Minor Change to the On-Post Record of Decision for RCRA-Equivalent Soil Covers, Rocky Mountain Arsenal

Fact Sheet

April 26, 2007

Figure 2 Cross Section of RMA RCRA-Equivalent Cover

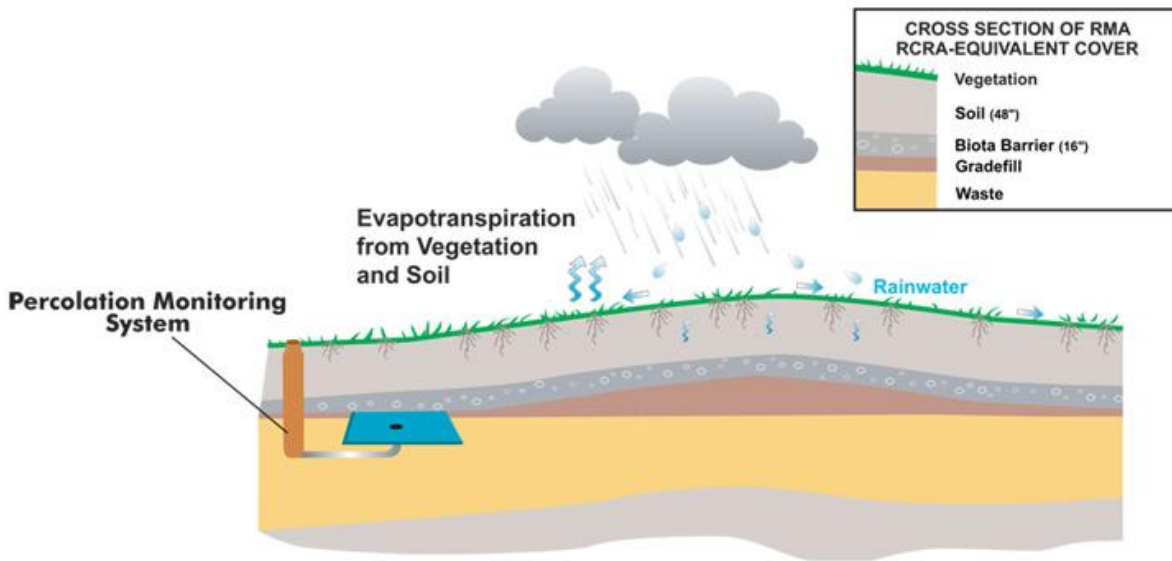
The change from non-RCRA-equivalent to RCRA-equivalent covers requires several changes to the projects. The primary change is the compliance standard for percolation of water through the covers. The RMA's RCRA-Equivalent Cover Demonstration Project established a performance

standard for percolation of no more than 1.3 mm/year (RVO 1998). In order to provide cover compliance monitoring, cover construction will include a measurement tool (percolation monitoring pans known as lysimeters) to measure water percolation below the soil covers.

The change to RCRA-equivalent covers also requires the application of more stringent soil type requirements for construction. Following the completion of the RCRA-Equivalent Cover Demonstration Project field demonstration, an evaluation was conducted to establish design criteria for the full-scale RCRA-equivalent cover implementation projects. An assessment of the test cover soils used in the field demonstration and further evaluation of soil properties were conducted to ensure that the full-scale cover soil material and placement specifications would result in cover performance equal to or better than that achieved in the field demonstration. As a result, specific criteria for soil textures were created (TtFW 2005c). Construction of RCRA-equivalent covers will use these criteria in selecting the appropriate soils for the covers.

During the RCRA-Equivalent Cover Demonstration Project, it was determined that during relatively wet weather periods, an additional impediment to percolation, referred to as a capillary break, was forming at the bottom of the test covers due to the contrast in pore size between the finer-grained cover soils and the underlying geotextile (a coarser material) that was placed as part of a geocomposite drainage system to collect and measure percolation. Further data review from the demonstration project led to the conclusion that the combination of the cover soils and the capillary break in the test covers was sufficient to meet the 1.3 mm/year percolation standard. Consistent with subsequent laboratory testing, the capillary break design selected for use in the RCRA-equivalent covers incorporates a geotextile between the fine-grained cover soil and the coarse wildlife barrier surface to enhance the performance of the capillary break (TtFW 2005b).

The high visibility warning tape recommended during the Basin A design was eliminated in favor of high visibility (orange) geotextile. The geotextile, added to enhance the performance of the capillary break, provides a subsurface warning to humans and eliminates the need for the warning tape layer within the cover soil. Also, during design, a concern was identified for geotextile placement directly over the crushed concrete barrier. Therefore a bedding soil layer overlying the wildlife barrier was added to the cover design. The bedding soil will fill voids in the surface of the crushed concrete barrier layer and provide a relatively smooth surface for placement of the geotextile.
